November 10, 2022

Subject: Beresford Elementary School HVAC Replacement
San Mateo - Foster City School District
Aedis Project No. 2021011.04
DSA Application #01-120124

ADDENDUM NO. 1

1 EMS SYSTEM ARCHITECTURE

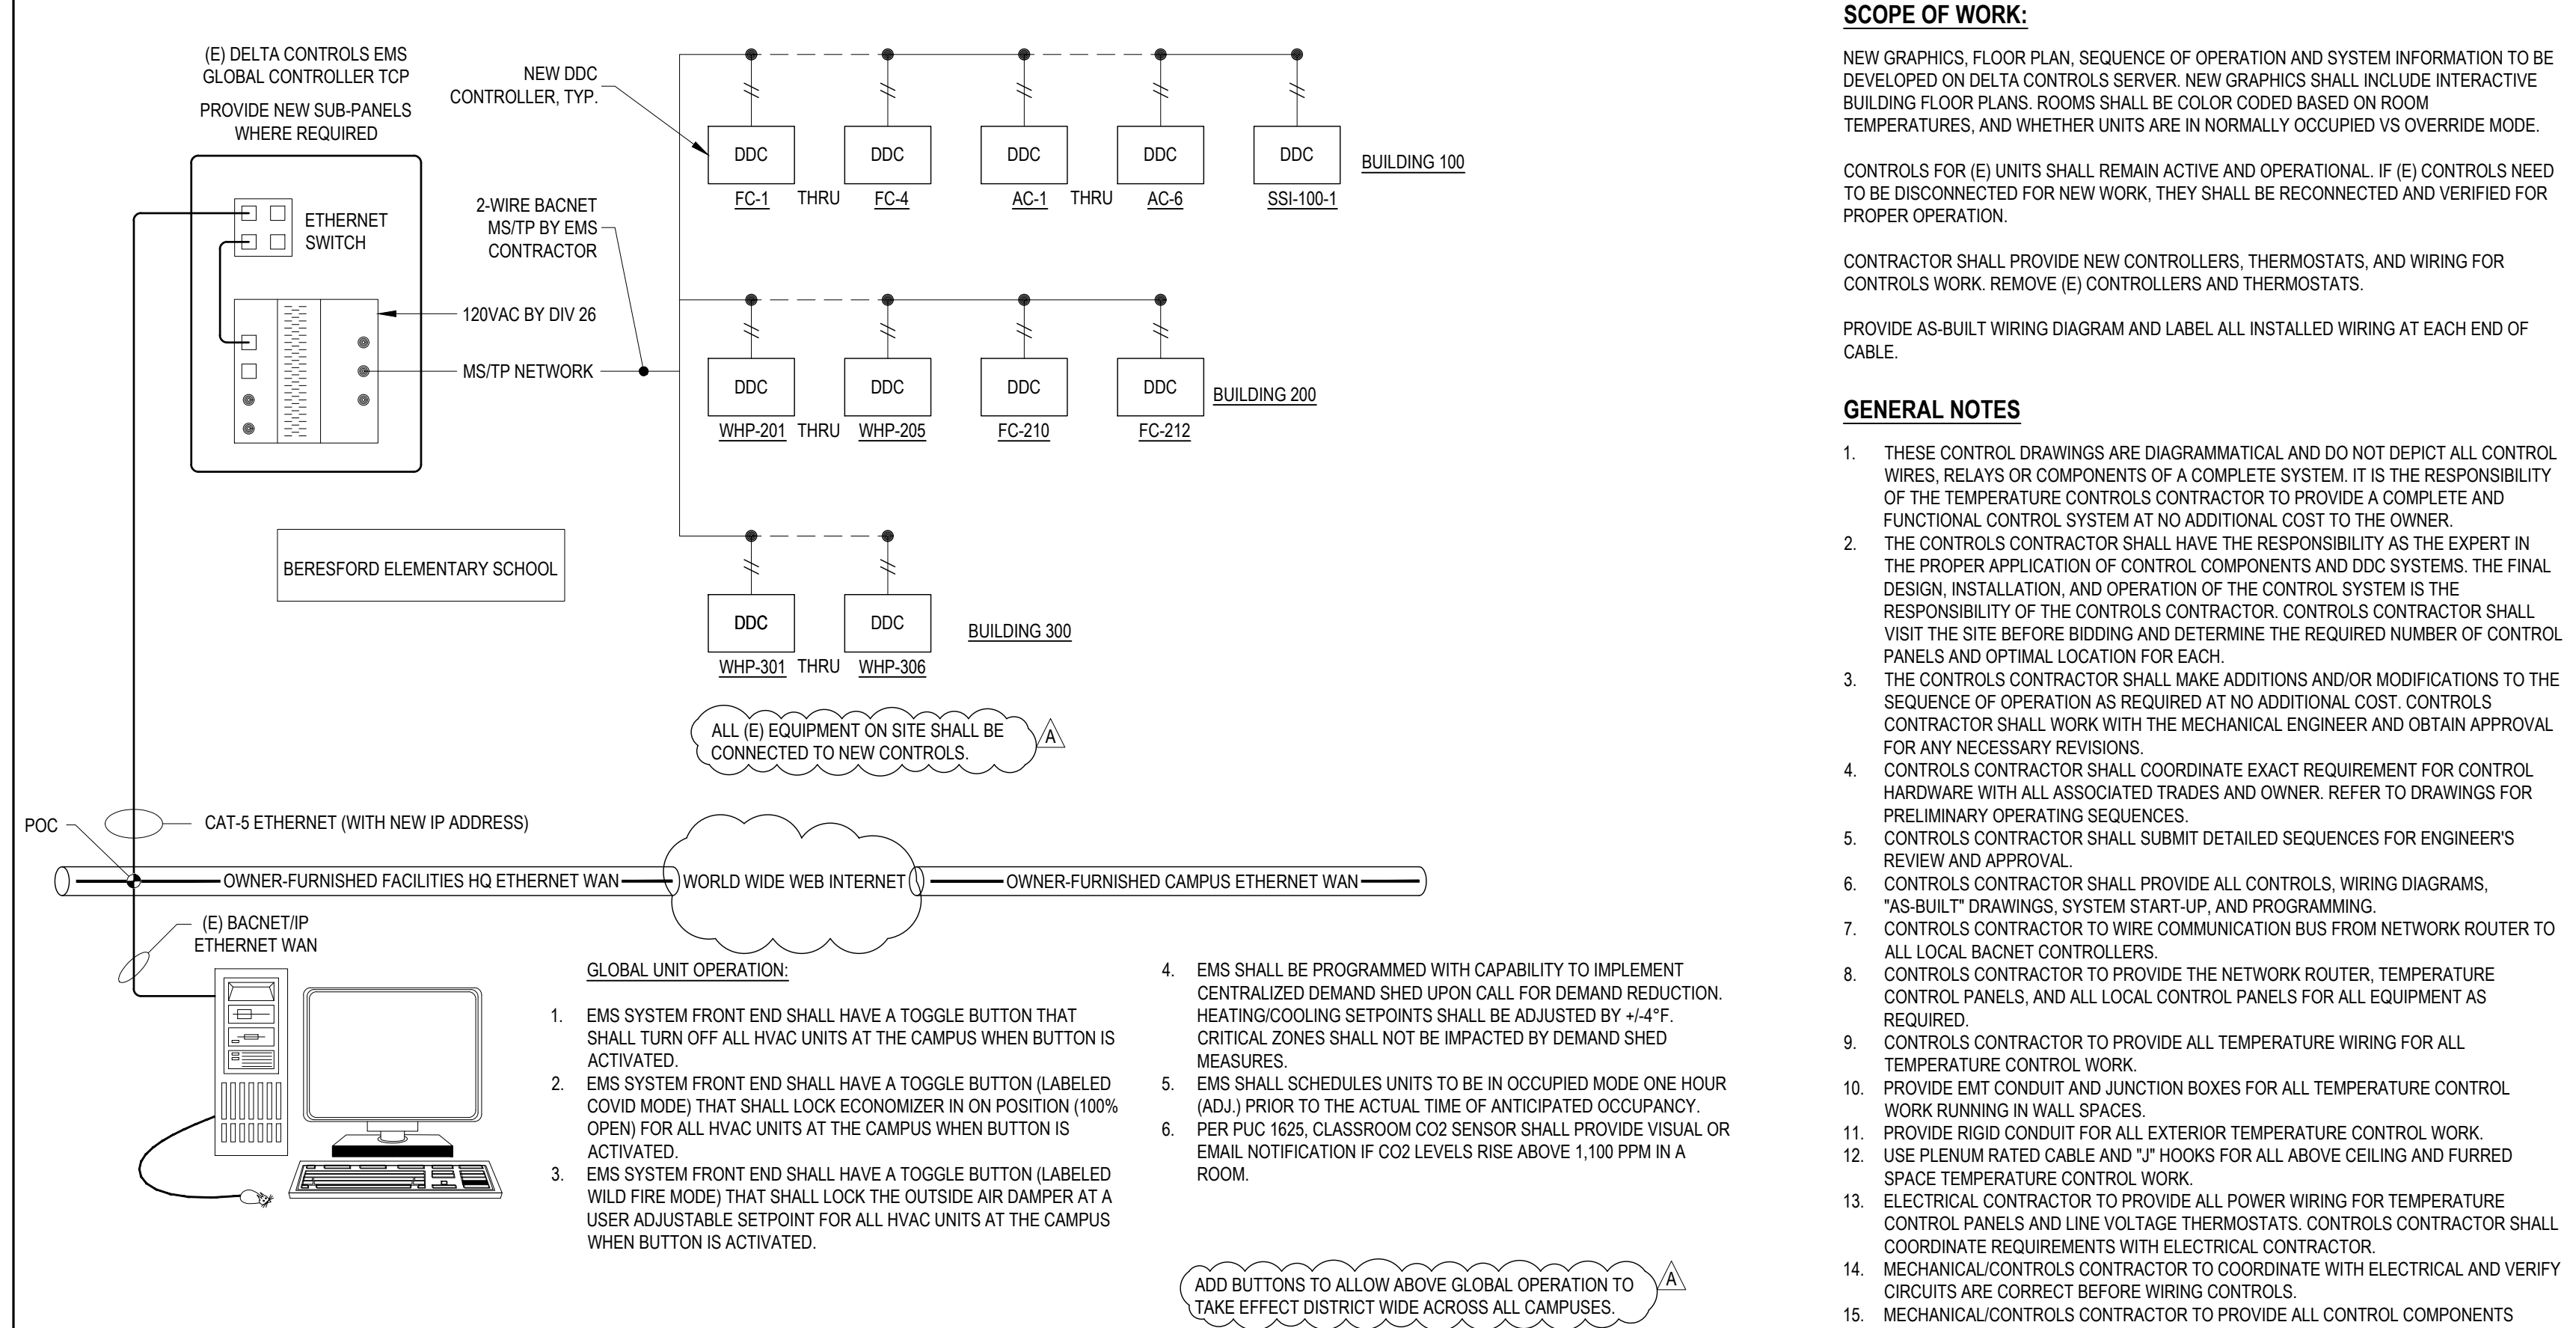
ITEM NO. 1.11: DRAWING SHEET MP5.01 – CONTROLS – MECHANICAL

Add: Notes for EMS System Architecture as clouded per AD-MP5.01

SHEET # **AD1-
MP5.02**

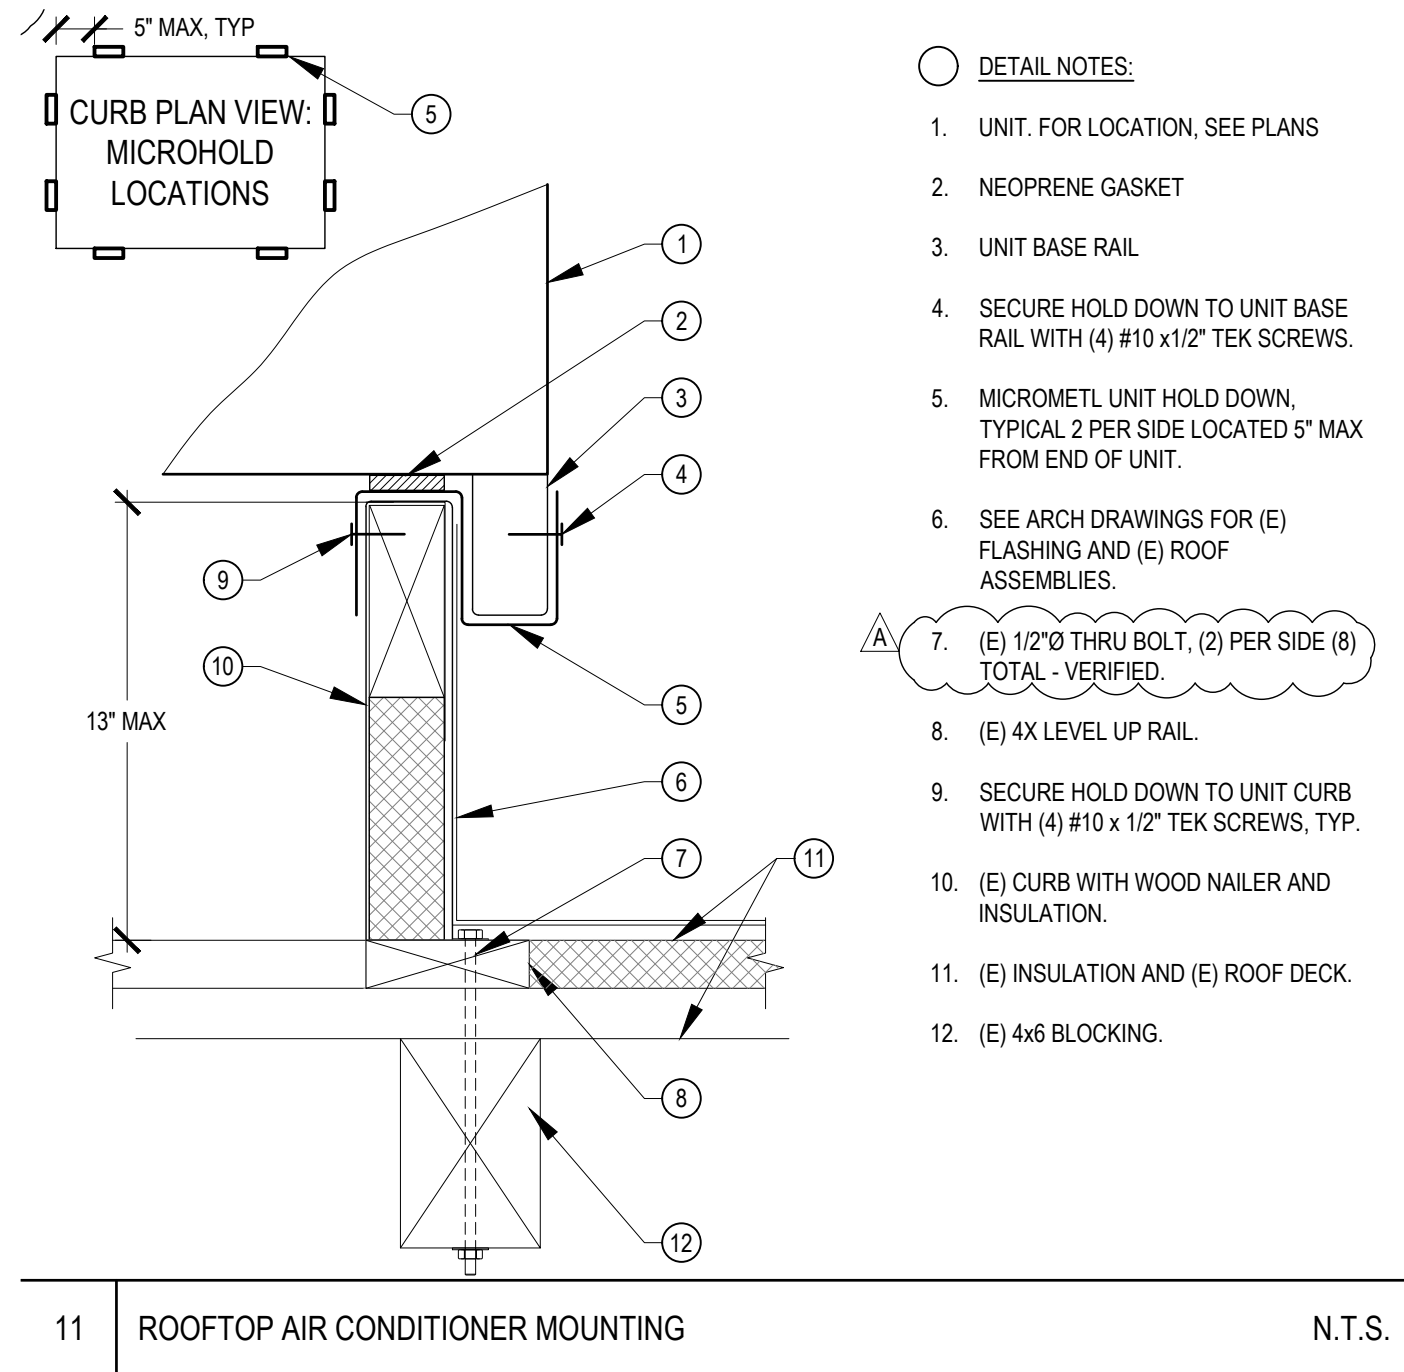
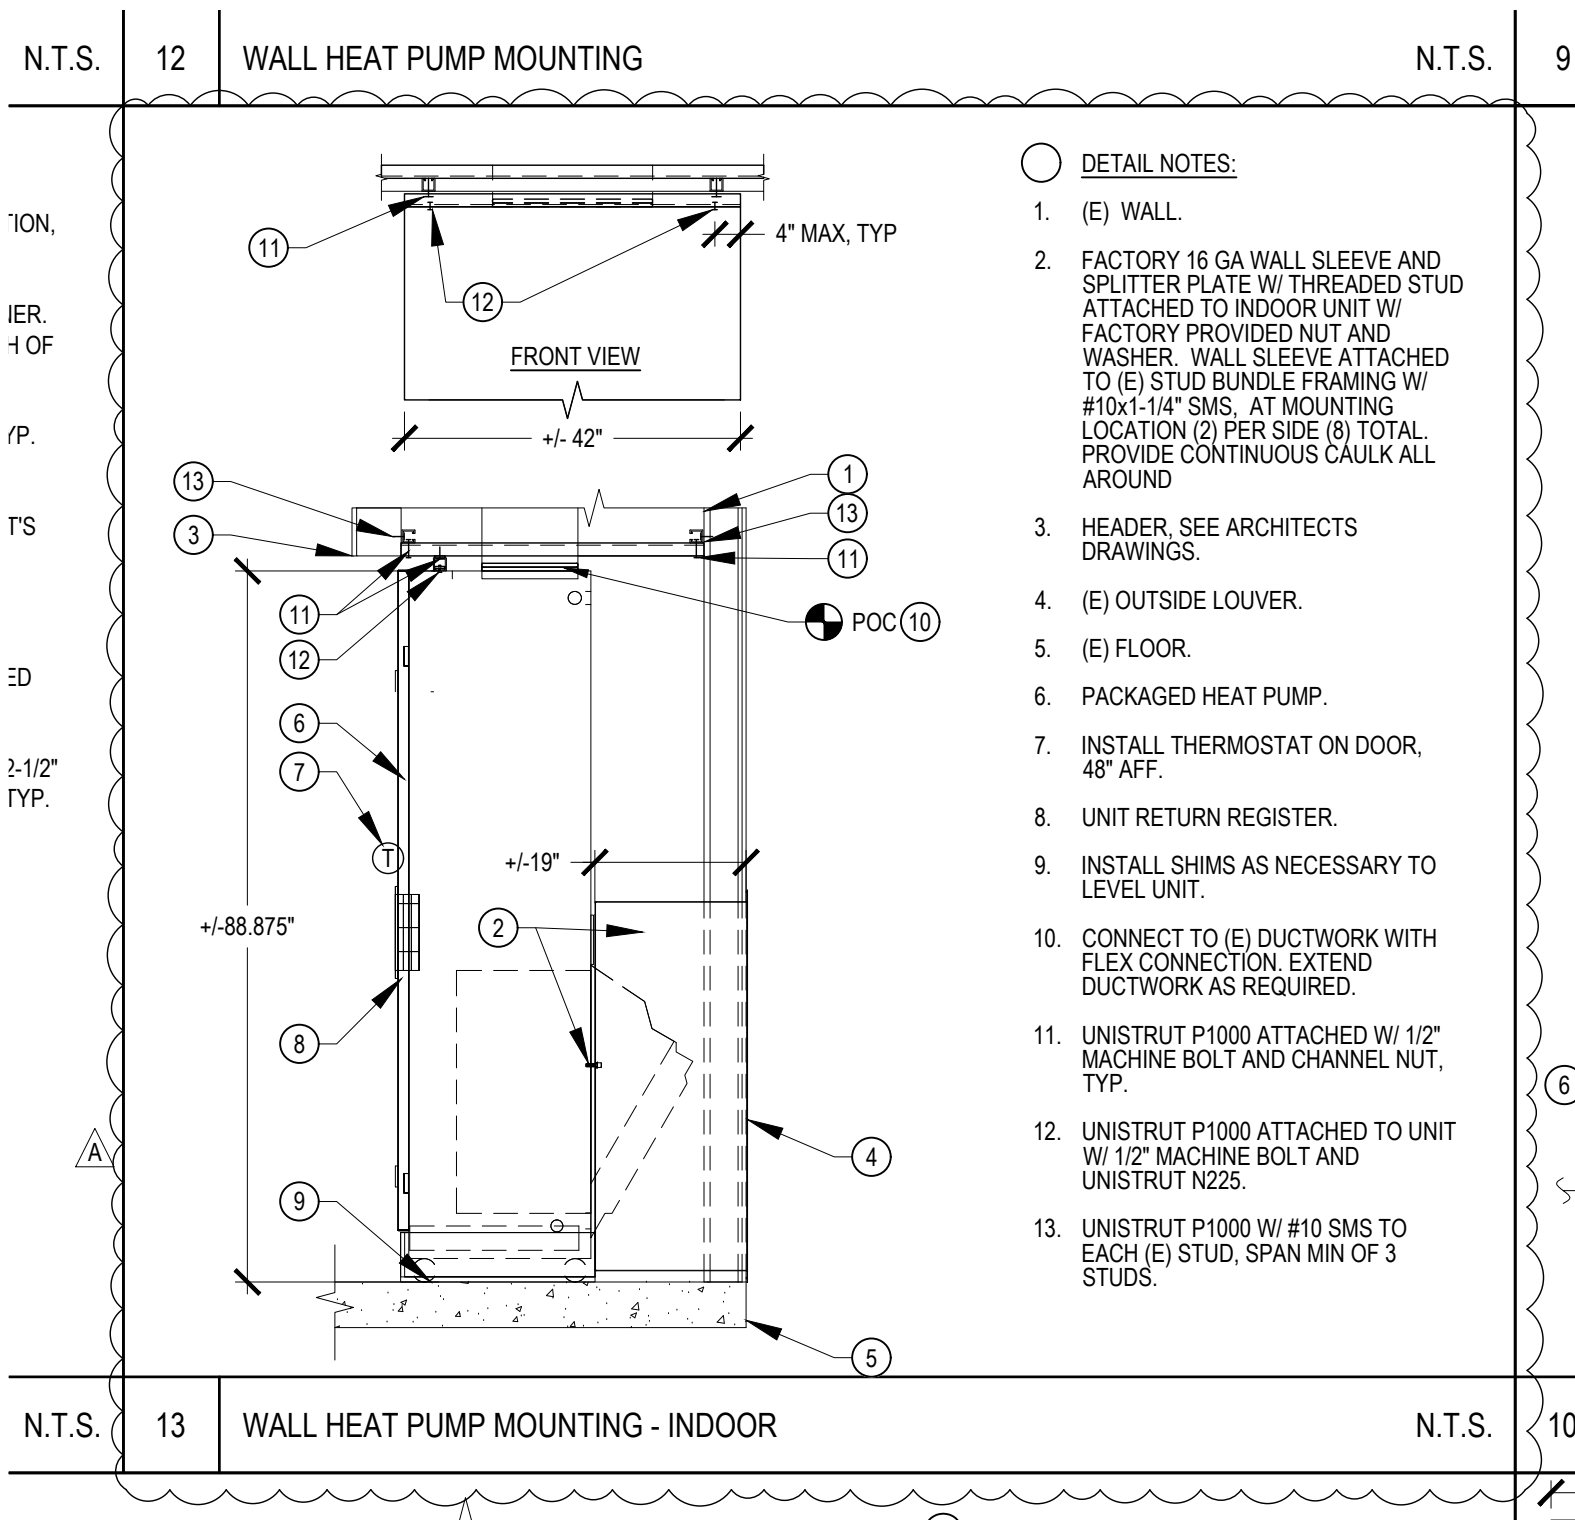
ITEM NO. 1.12: DRAWING SHEET MP5.02 – CONTROLS – MECHANICAL

- Add: Sequence of operation note #8 and wiring for condensate pump overflow protection to Wall Mount Split System Control Schematic as clouded per AD1-MP5.02

SHEET # AD1-
E2.2

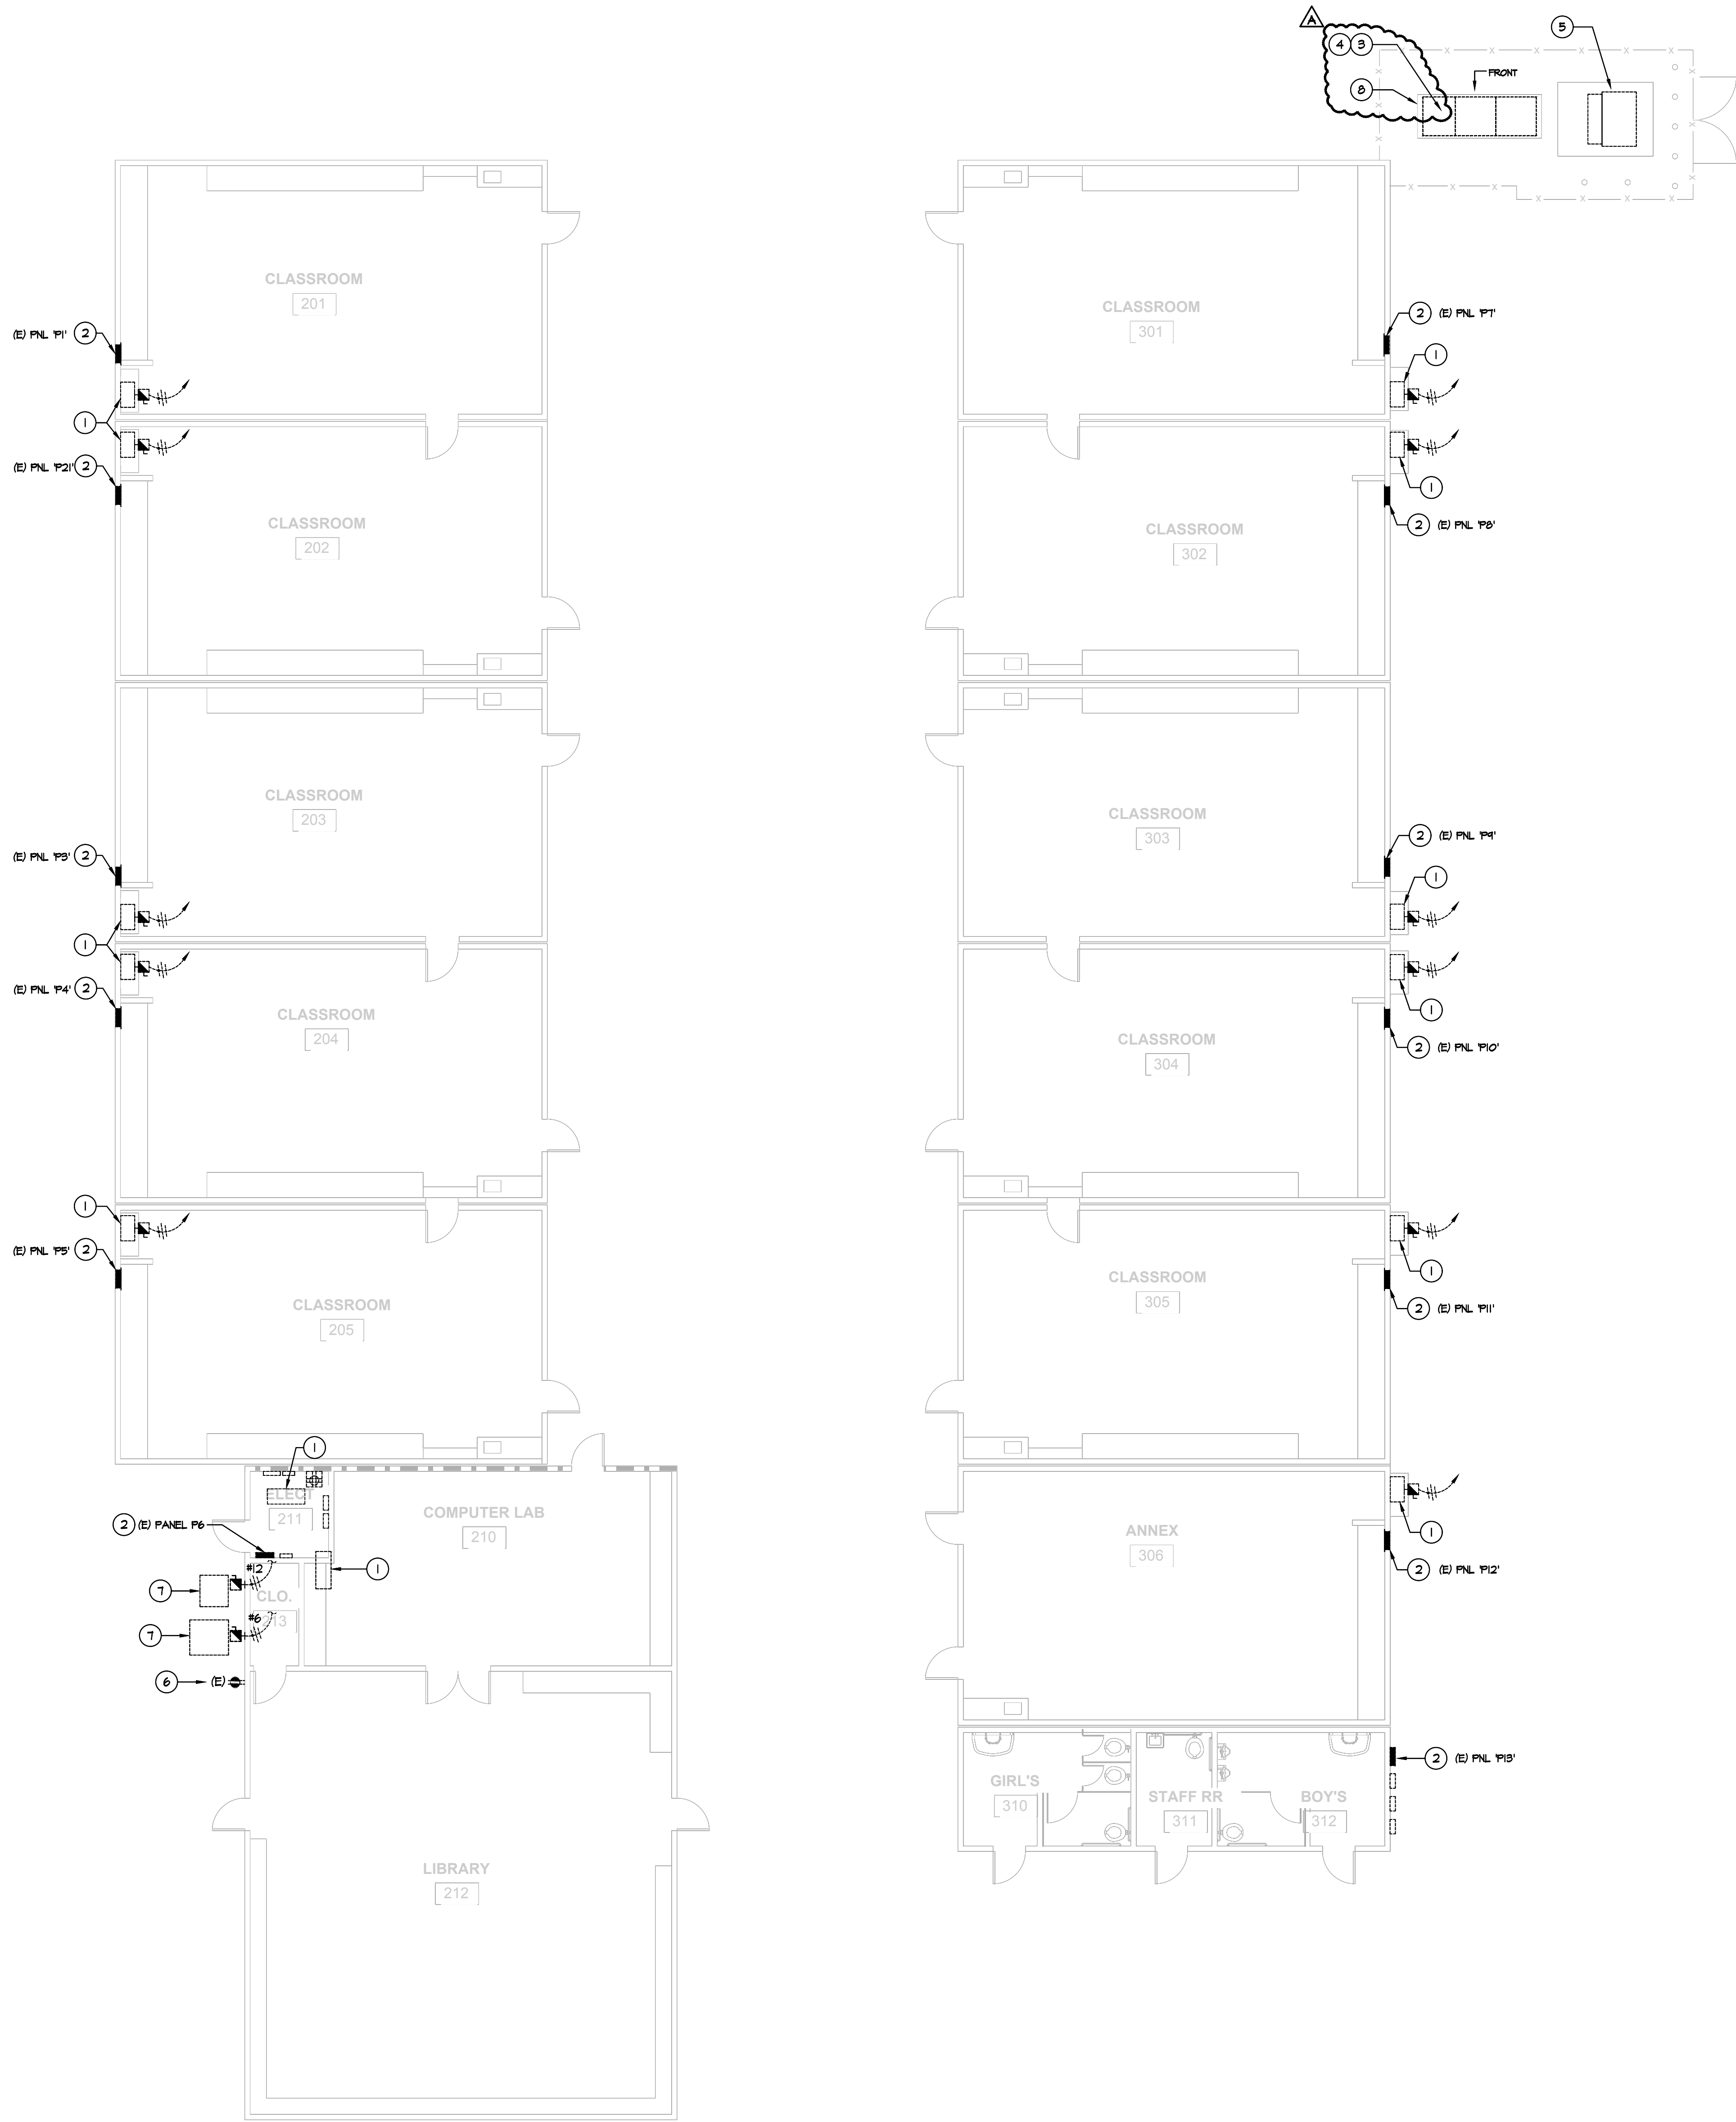
ITEM NO. 1.14: DRAWING SHEET E2.2 – DEMOLITION FLOOR PLAN – MODULAR BUILDING

- Revise: Demolition Sheet Note #3 as clouded per AD1-E2.2
- Add: Demolition Sheet Note #8 and associated tag as clouded per AD1-E2.2
